Addendum No. 2
March 15, 2021

Project: Jane Addams Elelmentary School – C.I.P. Addition And Renovations PD #3312
Project location: 2511 W. Brookings Street, Sioux Falls, SD 57104
Project number: 1105.2914.20

Architect: Architecture Incorporated

3
3.19
TYPICAL FRAMING DETAIL
NTS

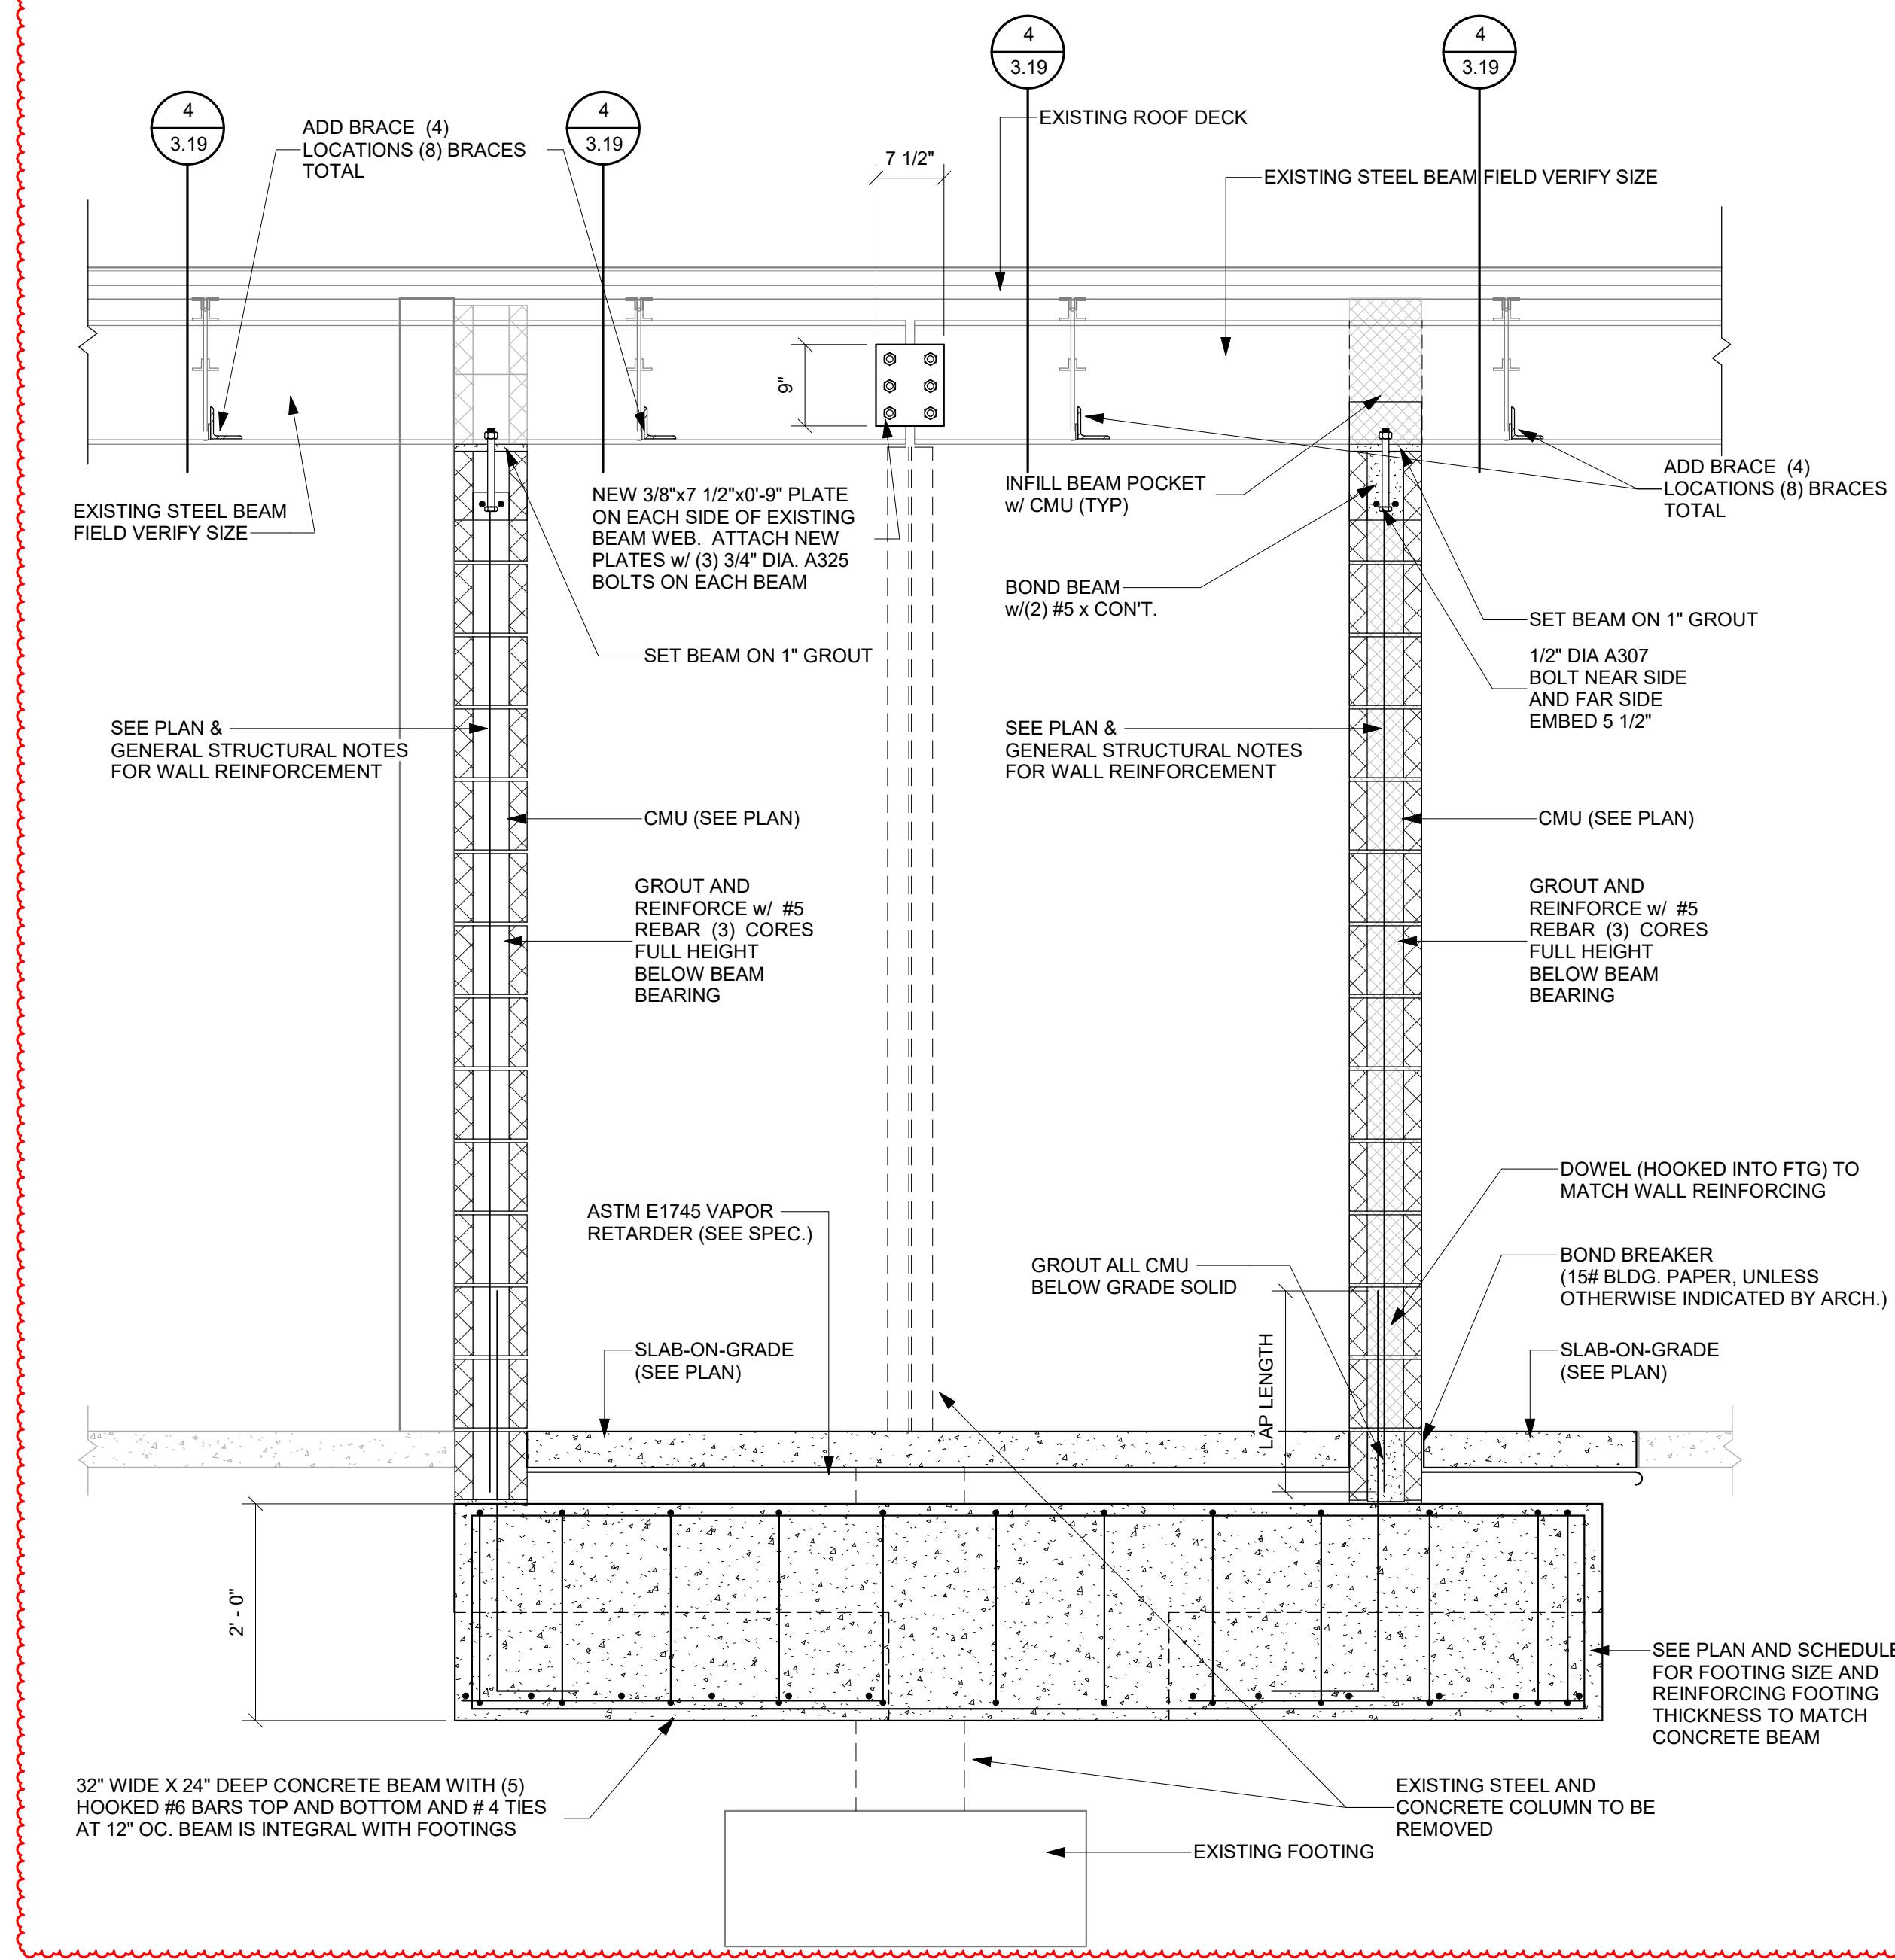
- a) Add new 32" wide x 24" deep grade beam integral with the F4 footings to support the new block wall along existing corridor wall in detail 3/3.19

DEMOLITION FLOOR PLAN - AREAS B & C

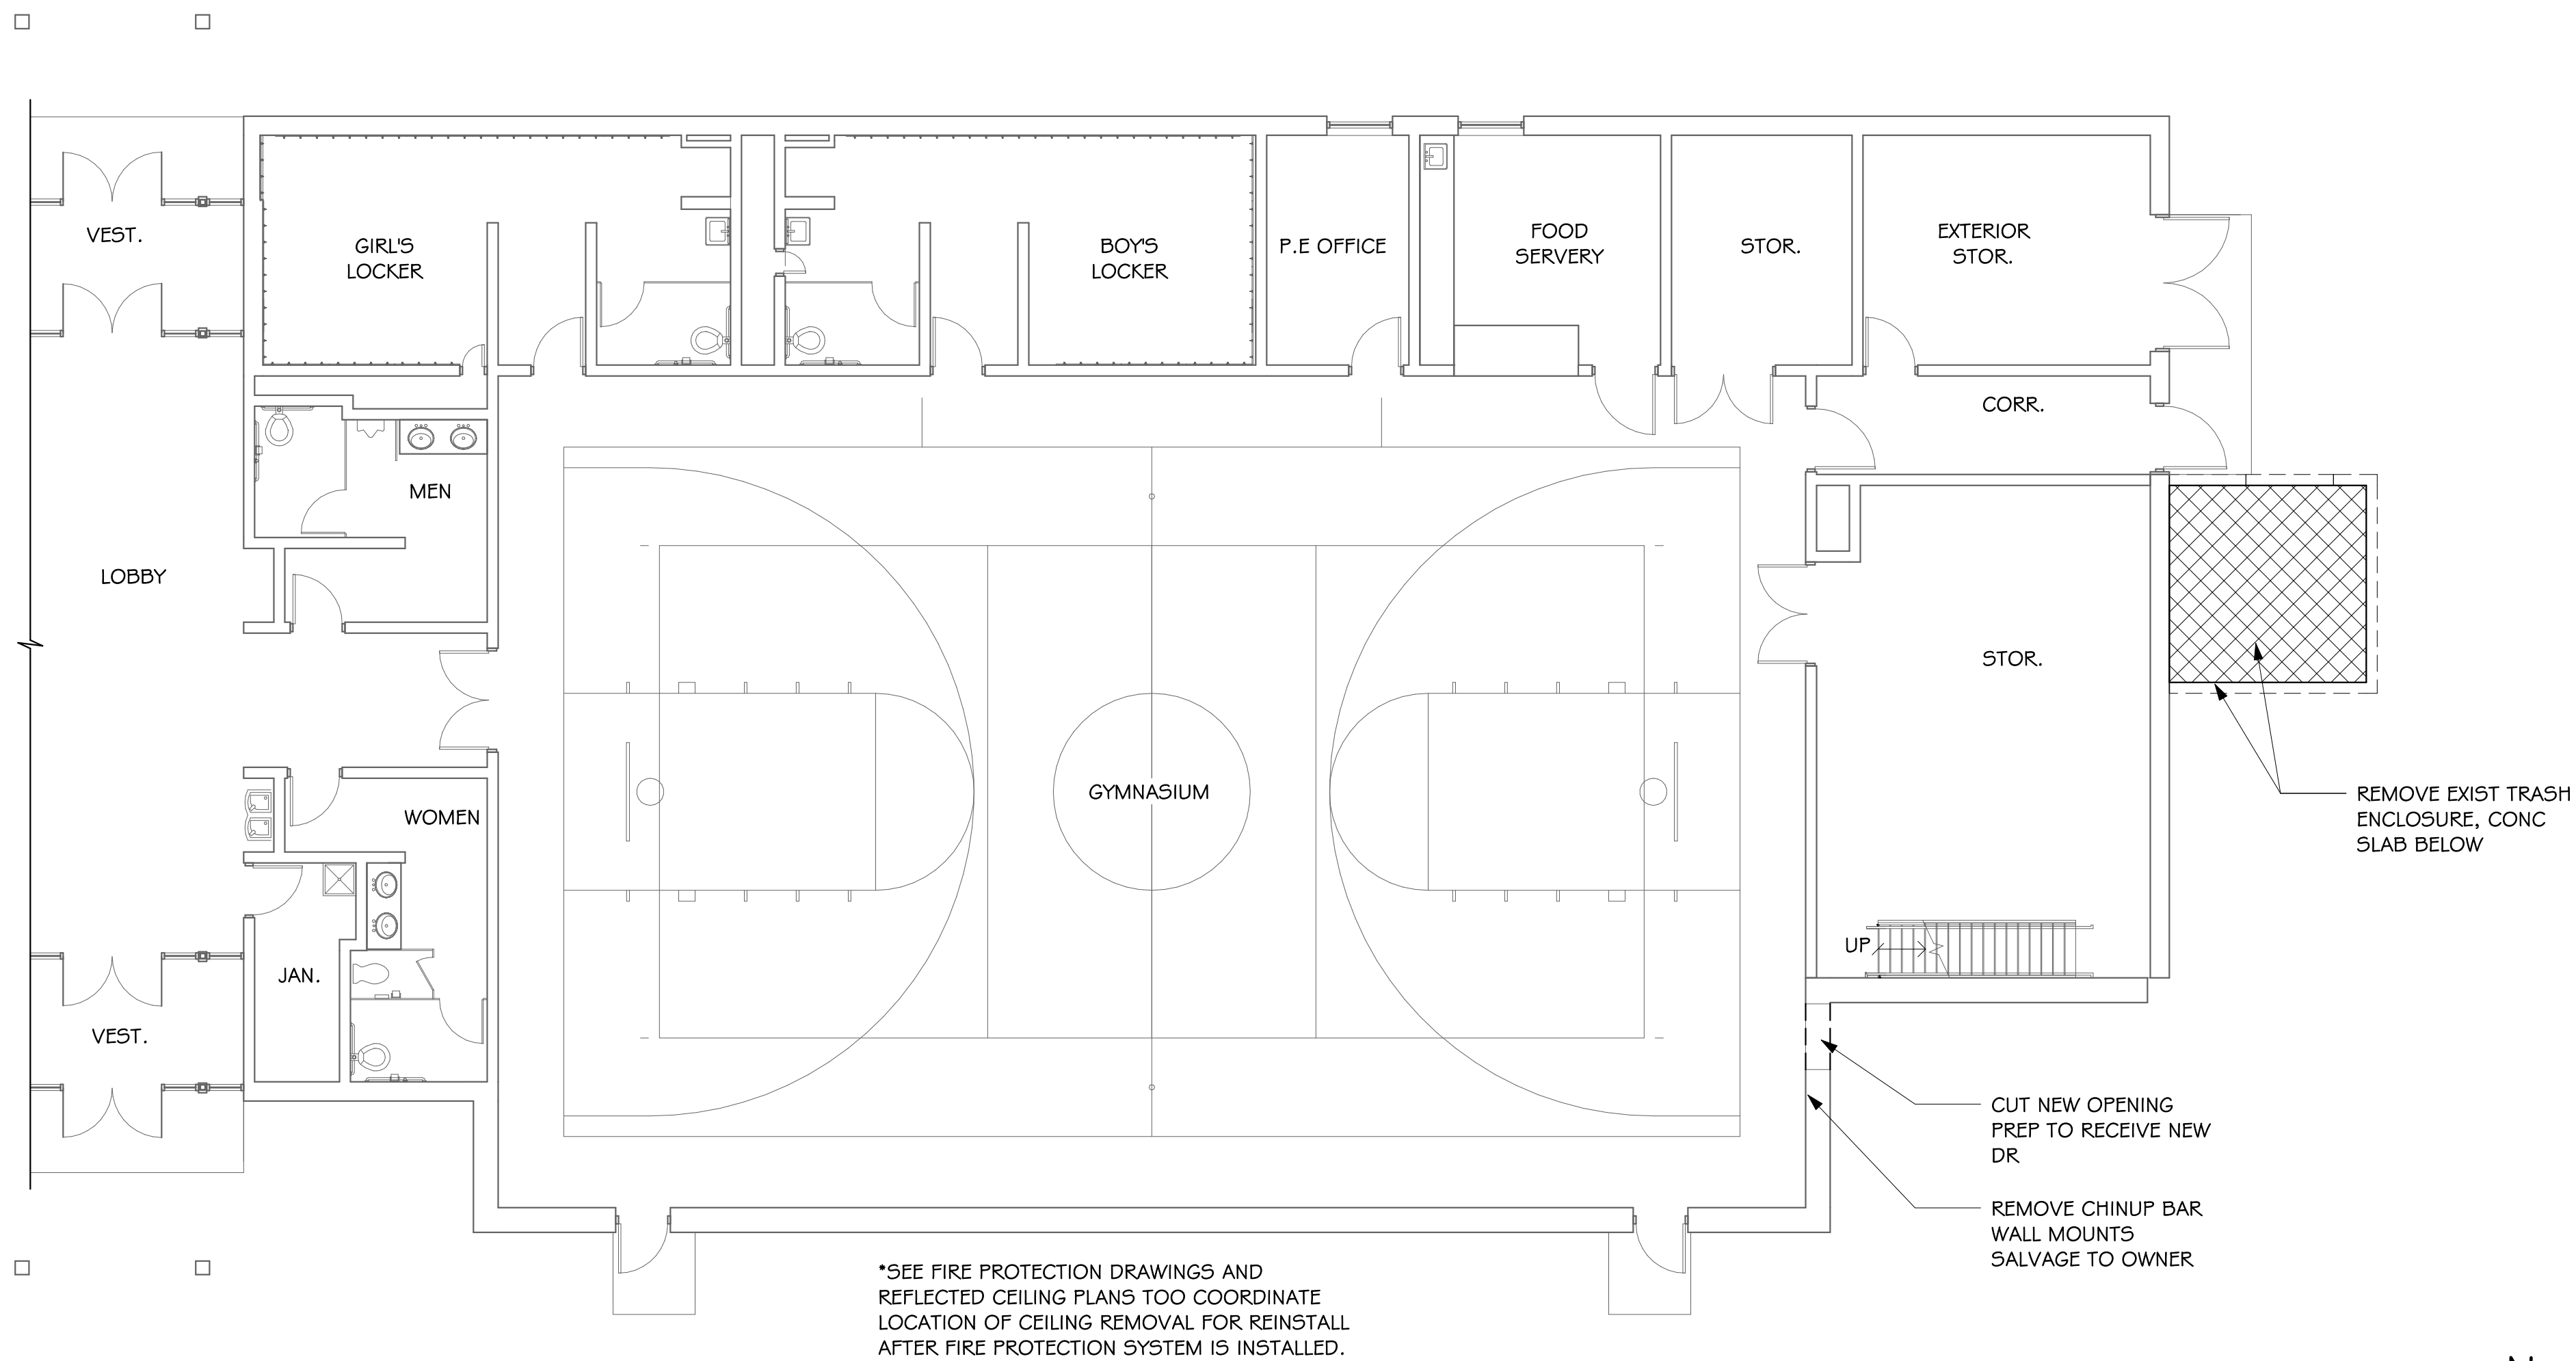
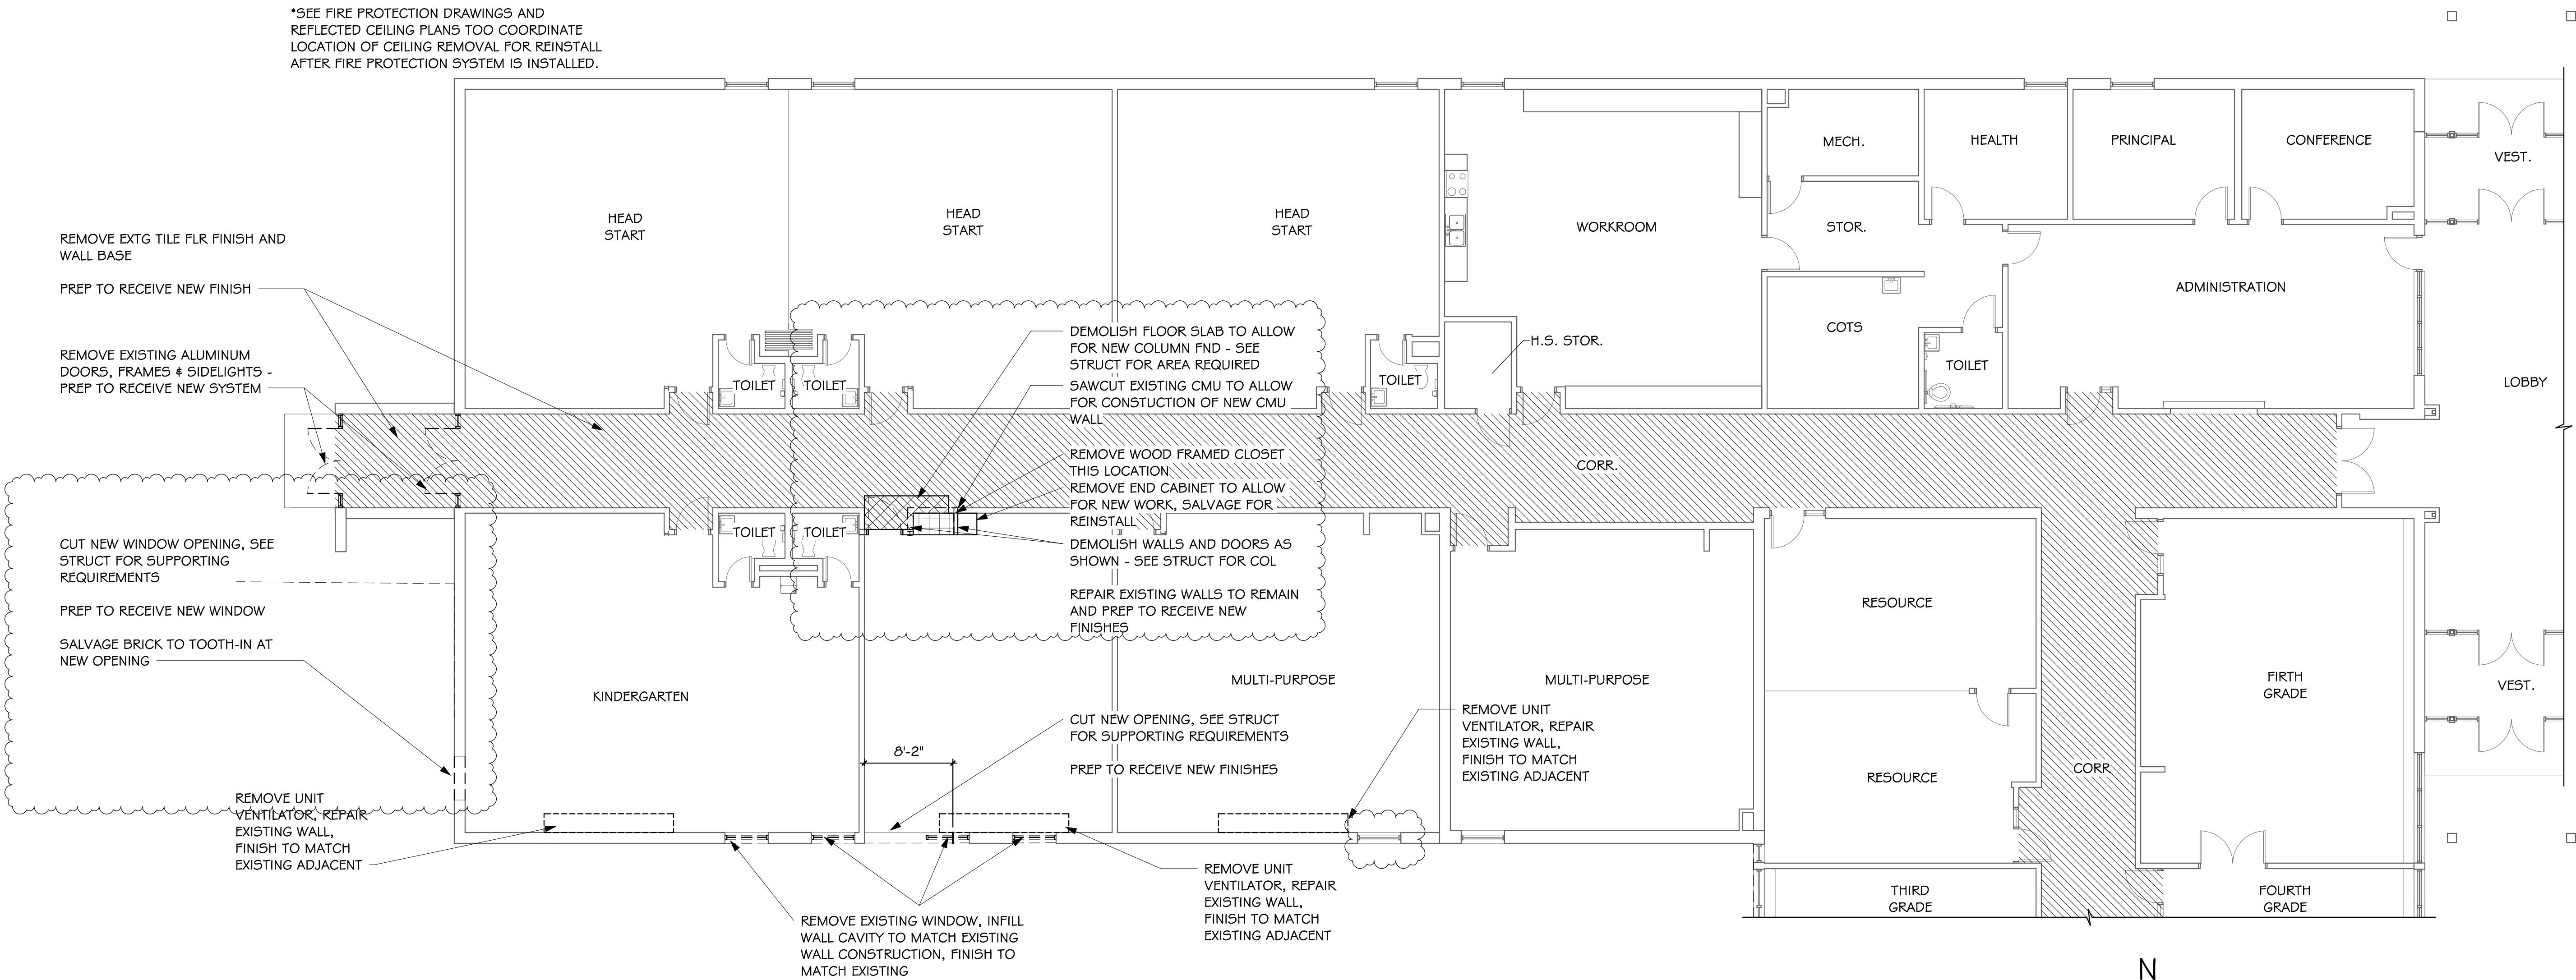
- a) See attached Revised Sheet 4.02 – DEMOLITION FLOOR PLAN AREAS B & C .
- b) Only (1) new window will cut into the existing facility, located on the west elevation. Disregard indication to cut new window into existing south wall of facility.
- c) Remove existing cabinet unit heater wall grate (3) locations, prepare to infill with CMU block at (2) locations and one with salvaged brick (1) location that will remain exposed, furthest east location.
